Zoning & Subdivision Committee
Tuesday, September 6, 2016, 1:30 pm

Staff Report – Village Neighborhood Section 4 Phase 1

**Subject: Village Neighborhood, Section 4, Phase 1
Final Plat Review – Comment Letter #1**

**Subject: The Courtyards at Jerome Village, Phase 1
Final Plat Review – Comment Letter #2**

VILLAGE NEIGHBORHOOD SECTION 4 PHASE 1

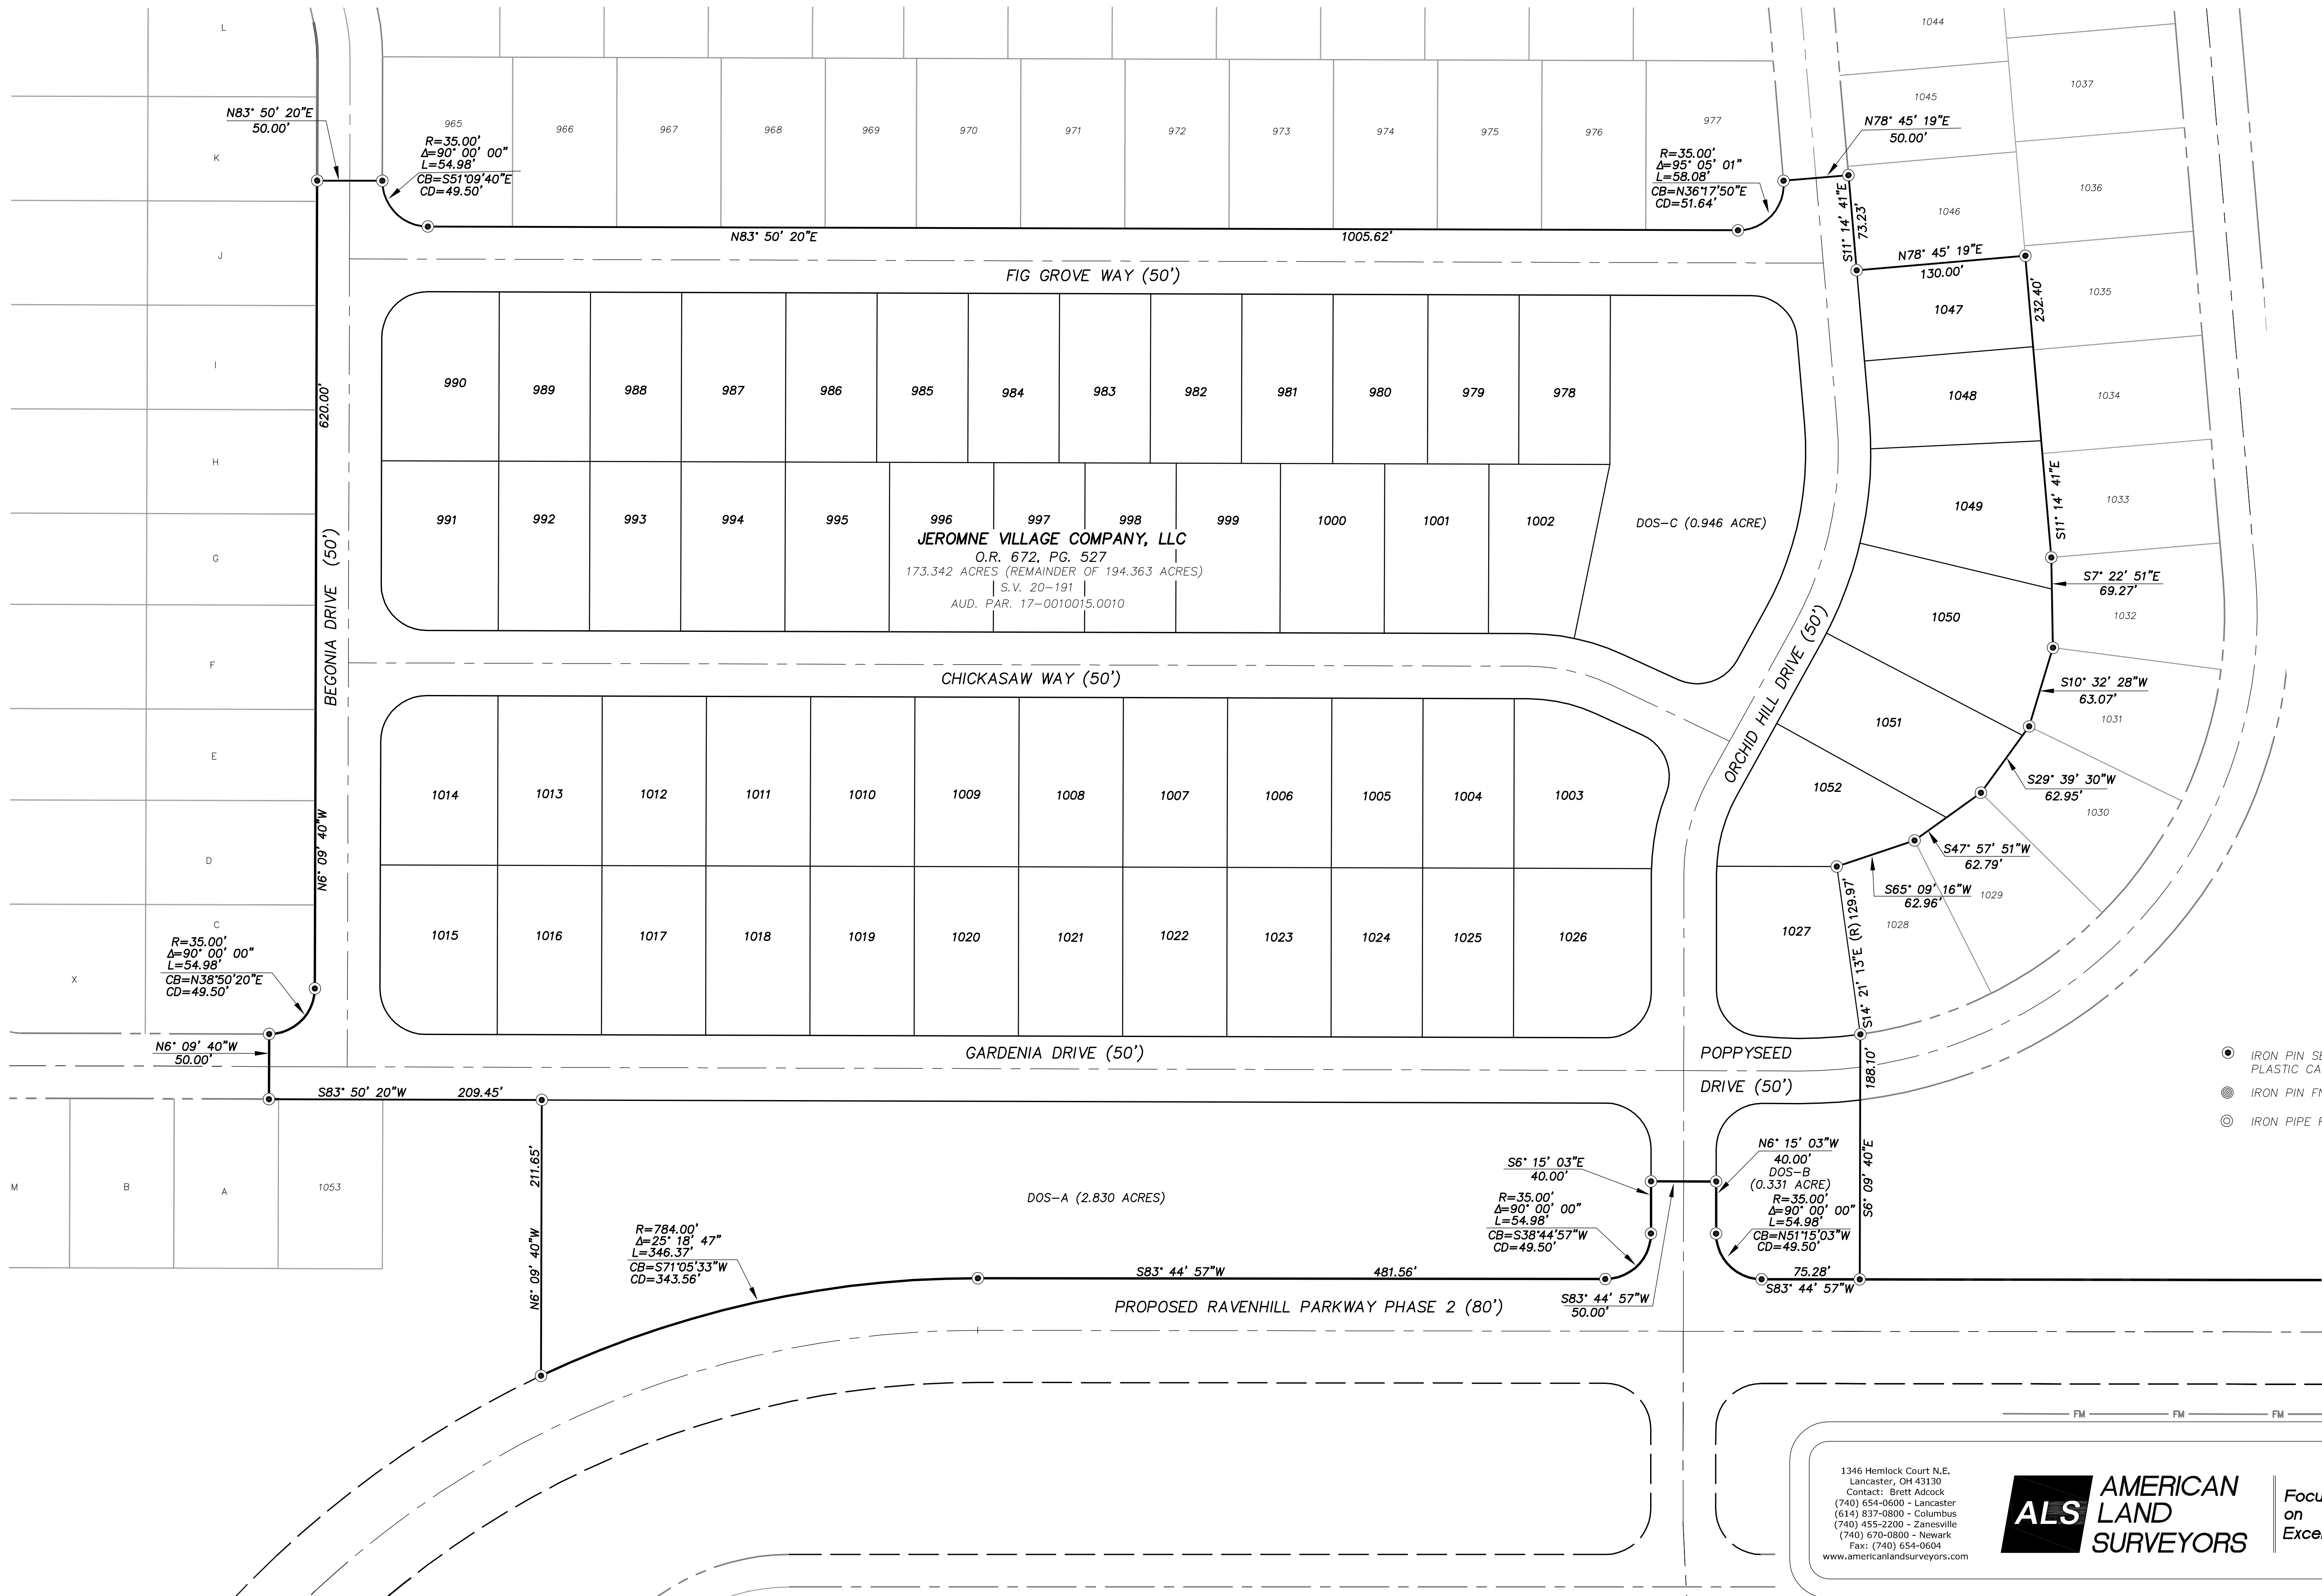
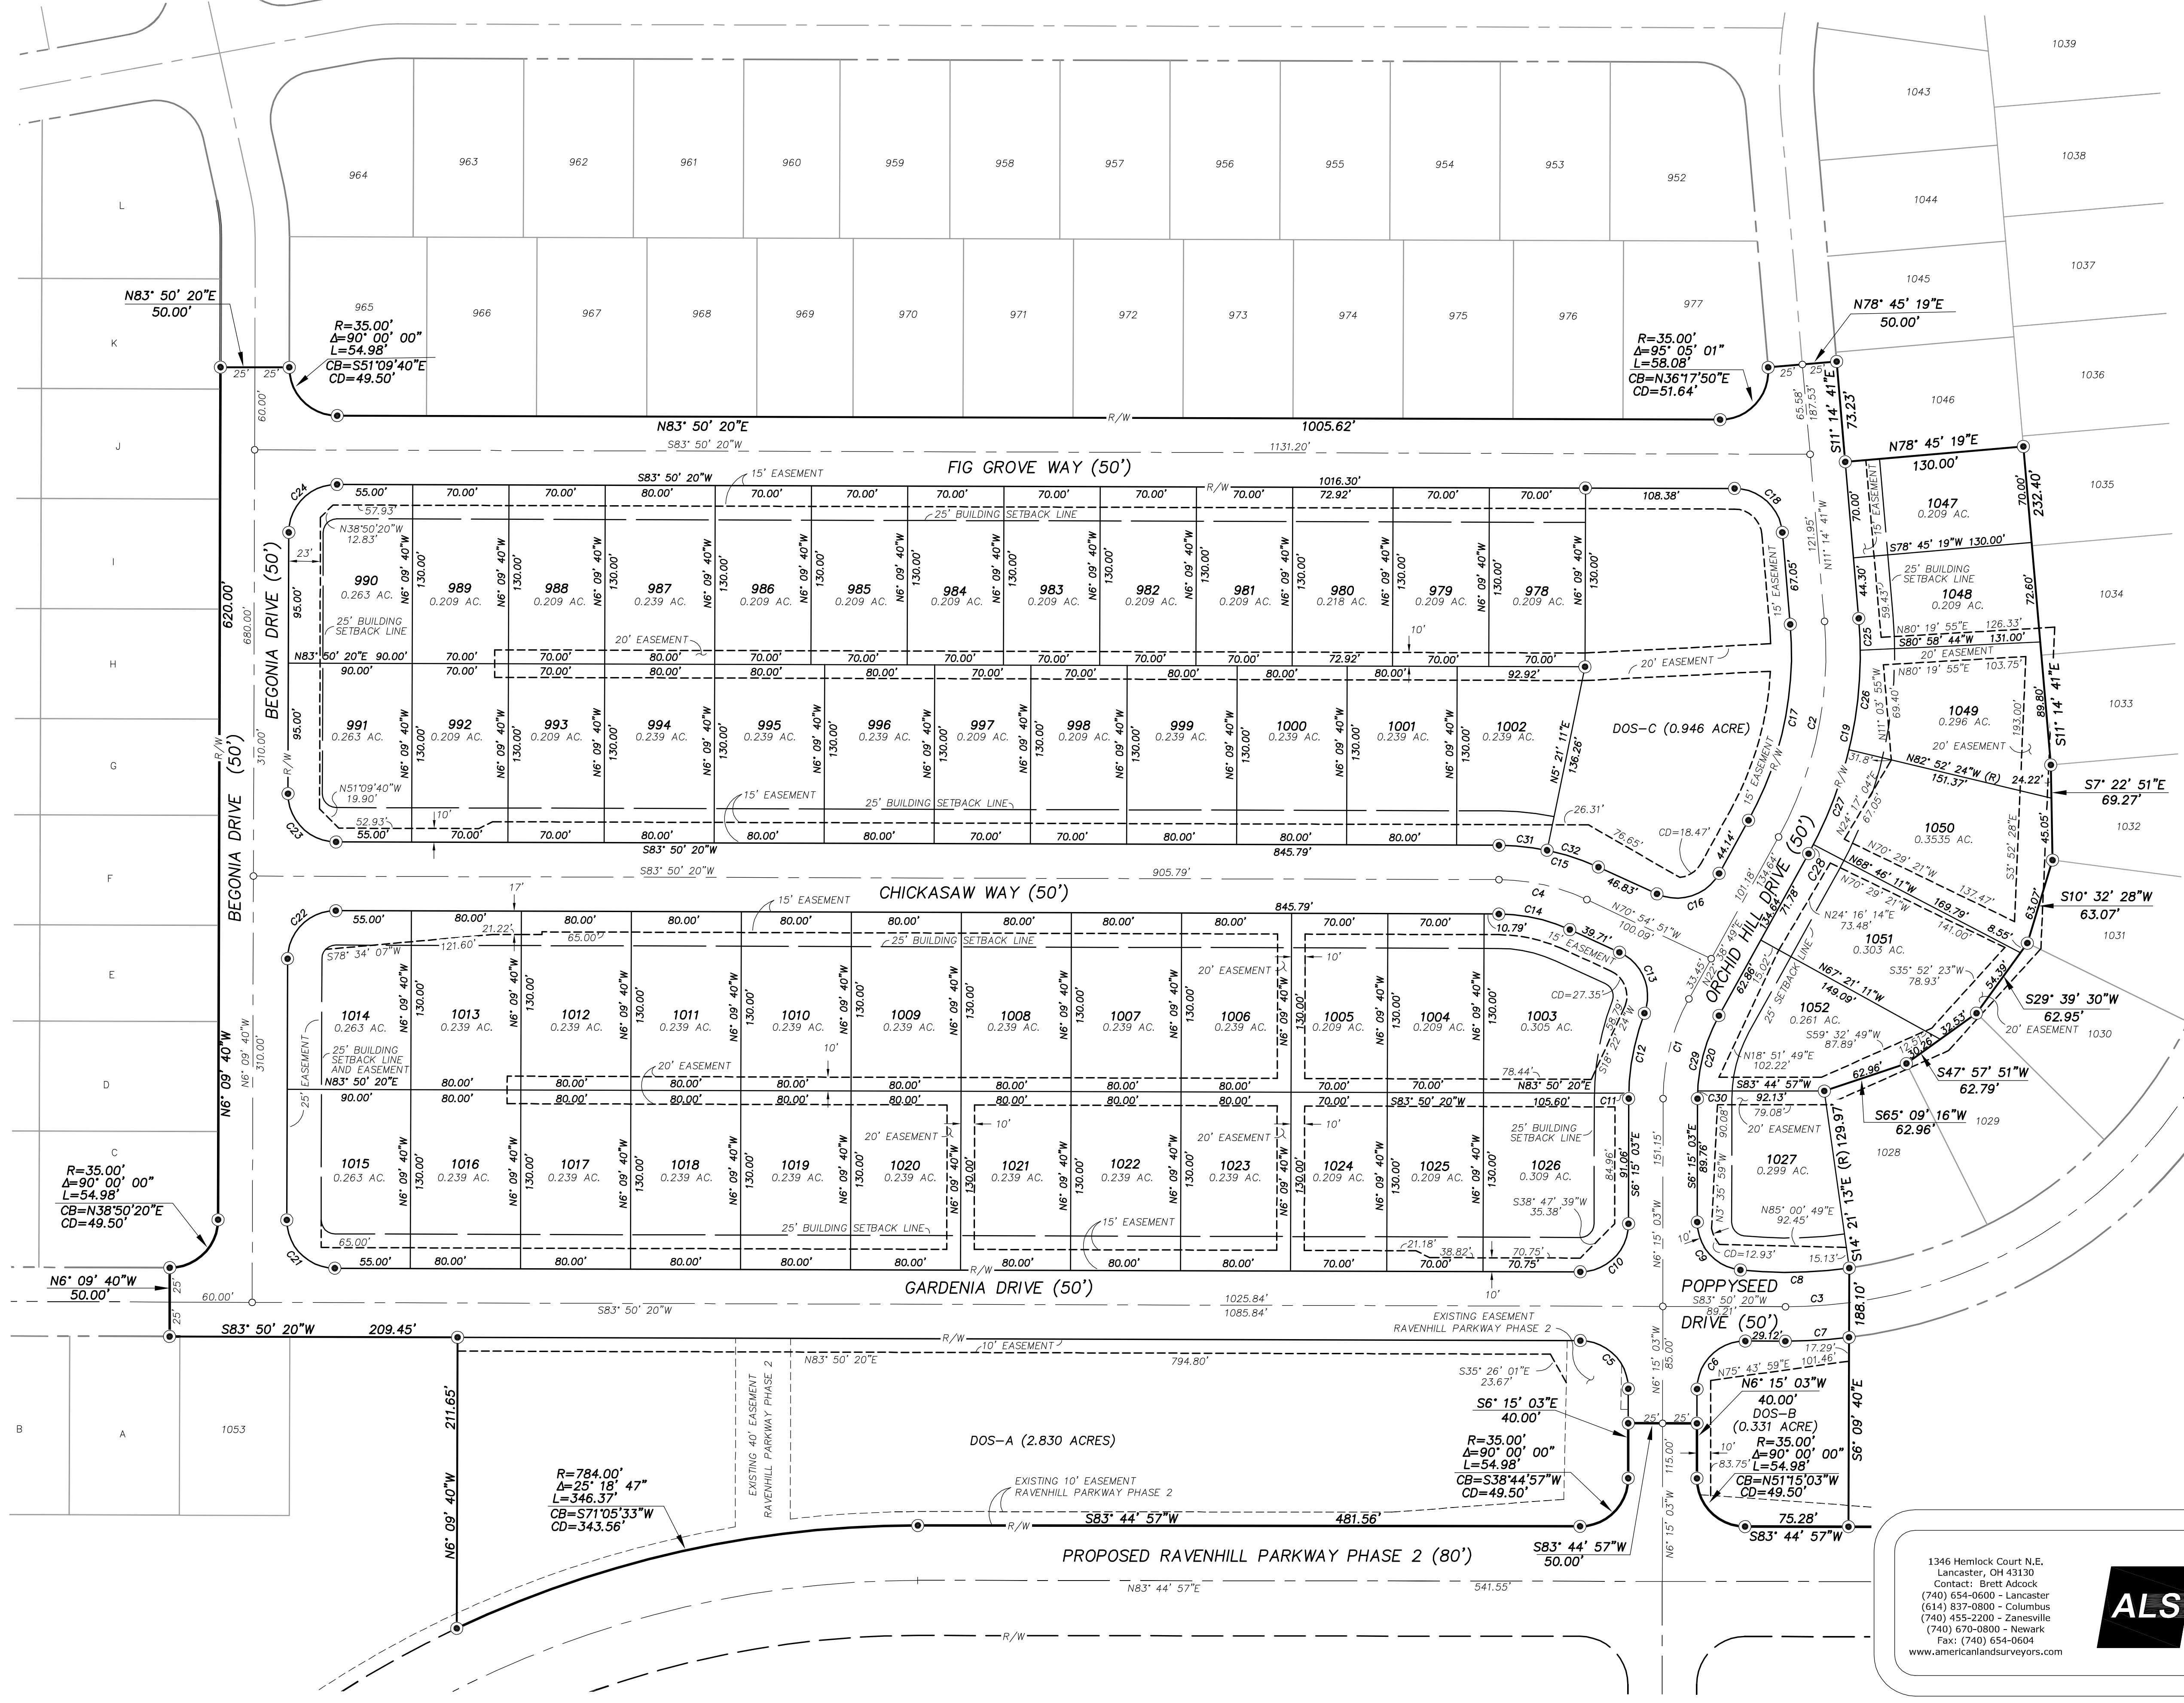
2. Add a notation for an iron pin to be set at the new intersection of the side yard and rear yard boundary of lot 1465.
 3. Due to the boundary adjustments, the acreages for lots 1465, 1466, and 1467 need to be updated.

4. In the Drainage Easement description on Sheet 1, replace the word "remove" with "replace" in the last sentence.
 5. Please add dimensioning for the straight line segment along the rear lot line of lot 1466, including the rear lot dimension of lot 1466 as well as the dimension from the northwest property corner of lot 1466 to the iron pin at lot 1465.

1. Add a notation for an iron pin to be set at the new intersection of the side yard and rear yard boundary of lot #1465.
2. Due to the boundary adjustments, the acreages for lots #1465, #1466 and #1467 need to be updated.
3. In the Drainage Easement description on sheet 1, replace the word "remove" with "replace" in the last sentence.
4. Please add dimensioning for the straight line segment along the rear lot line of lot #1466, including the rear lot dimension of lot #1466 as well as the dimension from the northwest property corner of lot #1466 to the iron pin at lot #1465.
